Subject: Docket No. 50-482: Revision of the Radiological Emergency Response Plan (RERP) for Wolf Creek Generating Station (WCGS)

**Summary of Changes to the Wolf Creek Generating Station (WCGS)
Radiological Emergency Response Plan (RERP)**

1. Procedure AP 06-002, "Radiological Emergency Response Plan (RERP)," Rev. 16

FIGURE 7
WCGE EMERGENCY RESPONSE FACILITIES

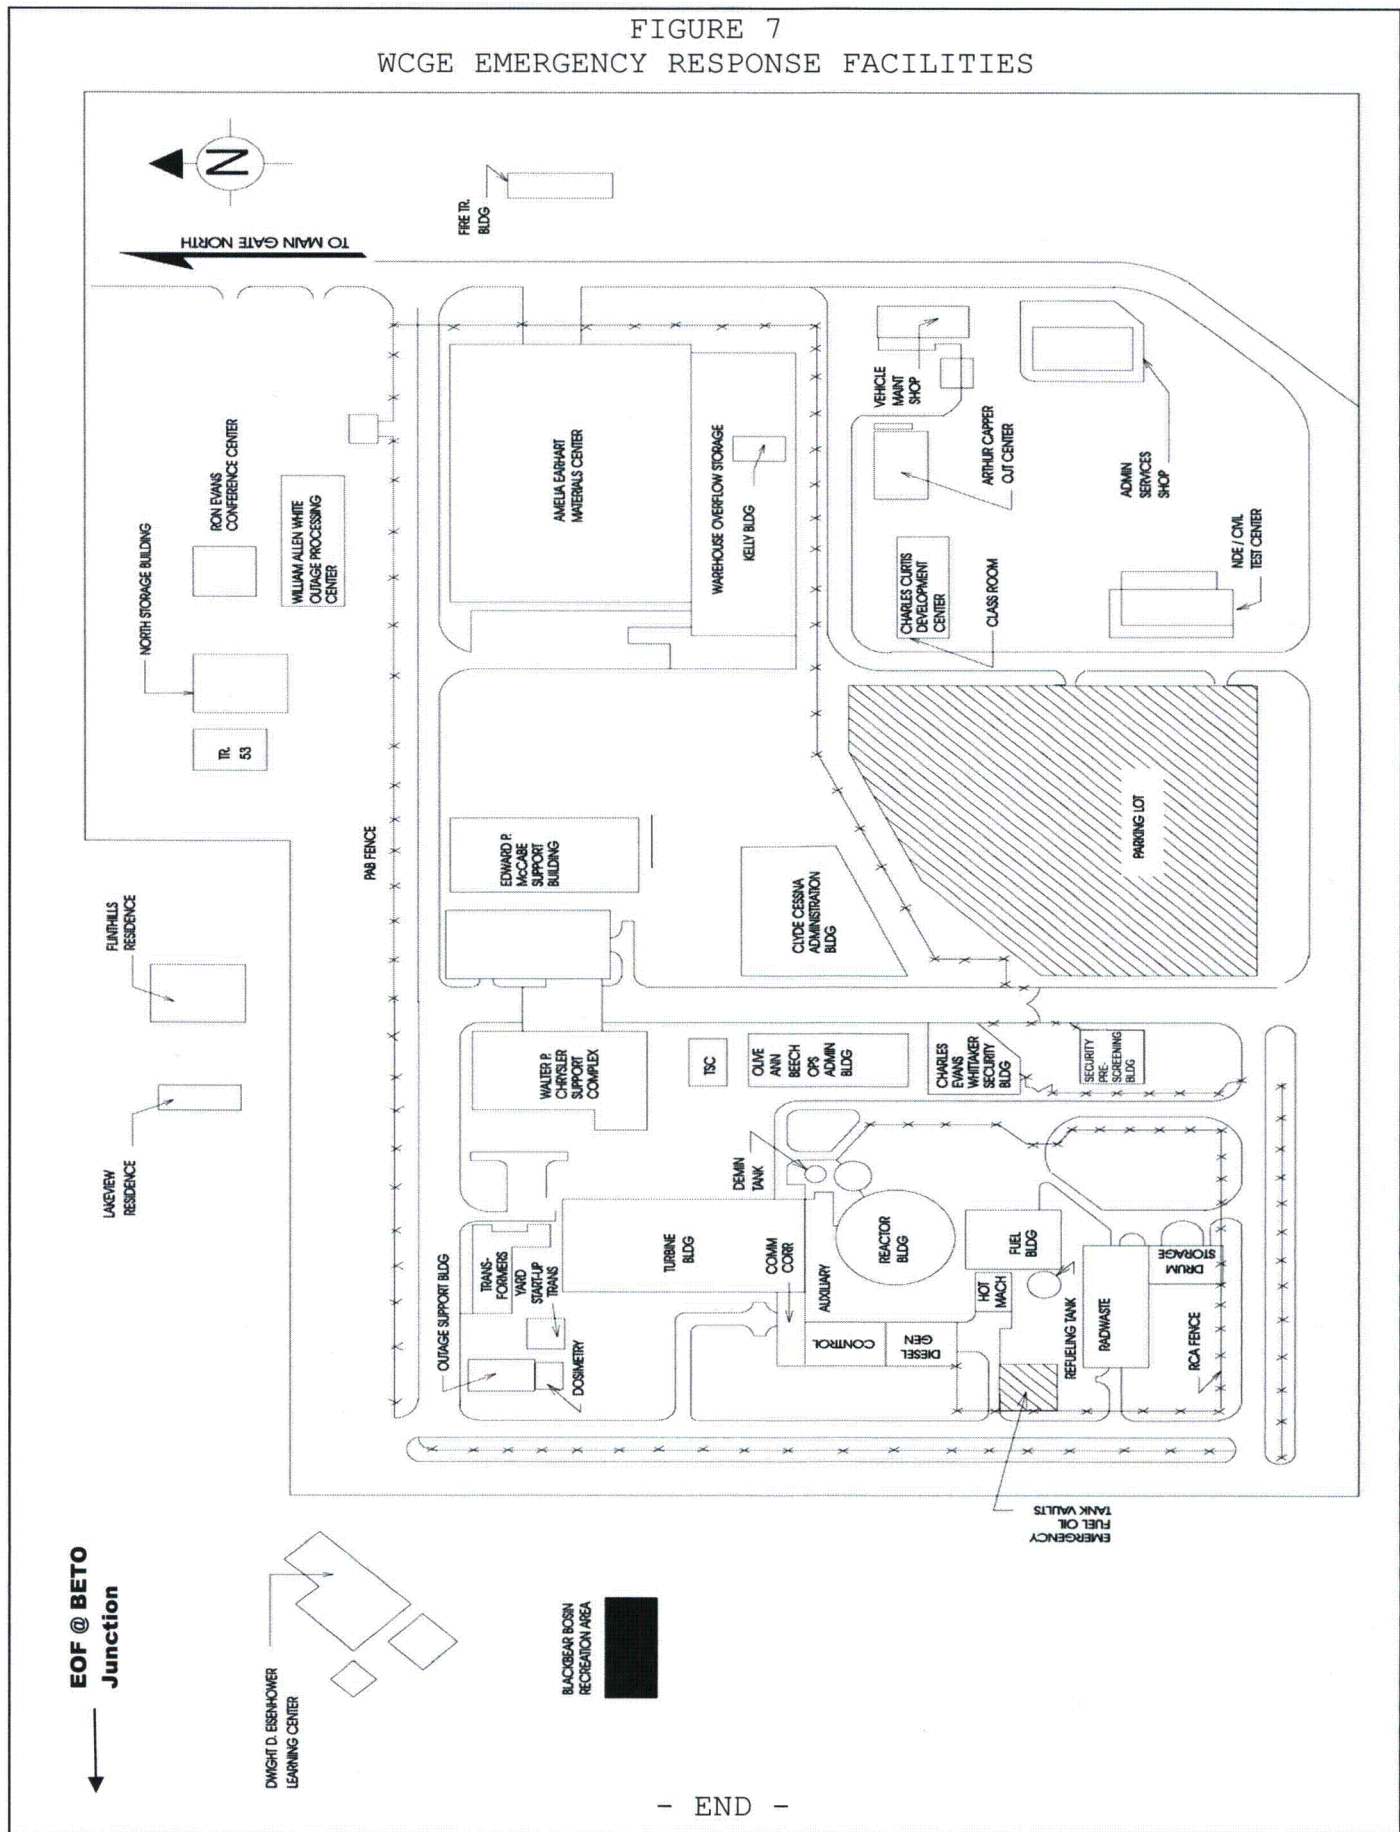
Wolf Creek Nuclear Operating Corporation (WCNOC) replaced the former near-site Emergency Operations Facility (EOF) with a new EOF, which contains the Alternate Technical Support Center (TSC) and Alternate Operations Support Center (OSC) required by 10 CFR Part 50, Appendix E, Section IV.E.8.d. The new EOF is approximately 12 miles from WCGS and became operational on December 9, 2014.

These changes affect sections 6.4, 6.6, 6.12, 6.14, 6.16 and Figure 7 of the WCGS RERP. These changes are being made to ensure compliance with:
